CHANGE ELEMENT ONCE EVERY 2 YEARS

Fuel handlers, the once-a-year change-out requirement of the advanced aviation forward area refueling system's (AAFARS) fluid filter separator element is too often.

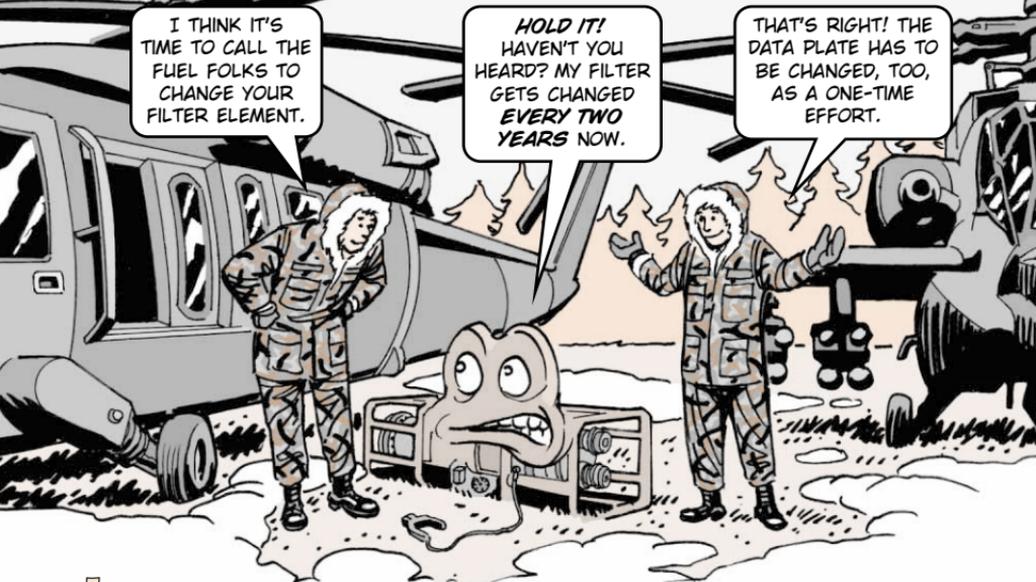
If you haven't done so, use the metal stamp set in your Common No. 1 tool kit, NSN 4910-00-754-0654, to change the AAFARS data plate info from 1 year to 2. Also, if there's space, stamp in the month and year the separator is changed for purposes of accountability. The marking of the data plate is a one-time occurrence, not every 2 years.

So instead of changing the AAFARS filter separator element every year, the TACOM headshed says to change it every 2 years. That's because every 2 years makes better use of the separator element without increasing its failure rate. Your cost to replace the element is reduced, too.
